**Re: GE-Pittsfield/Housatonic River Site  
Former Oxbow Areas A and C (GECD410)  
Revision to Second Addendum to Final Removal Design/Removal Action Work Plan**

GENERAL ELECTRIC COMPANY • PITTSFIELD, MASSACHUSETTS  
SECOND ADDENDUM TO FINAL RD/RA WORK PLAN FOR FORMER OXBOW AREAS A AND C

## EXCAVATION LIMITS

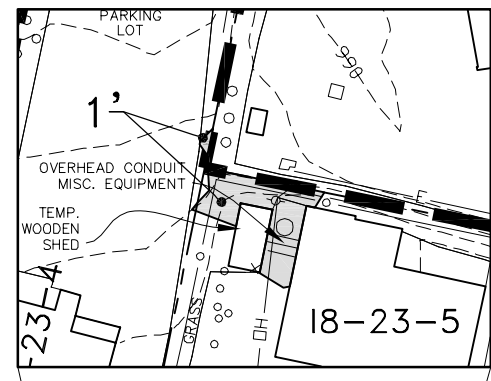
As demonstrated in the Second Work Plan Addendum, the remediation proposed therein would achieve the applicable residential Performance Standard for PCBs at Parcel I8-23-5 and those for PCBs and other constituents at Parcel I8-23-9. However, in response to EPA's May 31, 2006 letter, GE has elected to expand the proposed soil removal limits to include the top foot of soil beneath the pavement in the following areas (to the extent feasible based on the existence of on-site structures and equipment): (1) the paved areas on Parcel I8-23-5 that are associated with the soil samples within the top foot at locations RAA11-T2 and SB-415 through SB-421, as well as locations SB-308 and RAA11-X4; and (2) the paved area on Parcel I8-23-9 associated with the 0- to 1-foot soil sample at location RAA11-T10.5. This will involve the removal of an additional approximately 115 cubic yards (cy) of soil from the 0- to 1-foot depth increment – approximately 100 cy at Parcel I8-23-5 and approximately 15 cy at Parcel I8-23-9. A revised Technical Drawing 3 (Excavation Limits) showing the revised soil removal limits is attached to this letter.
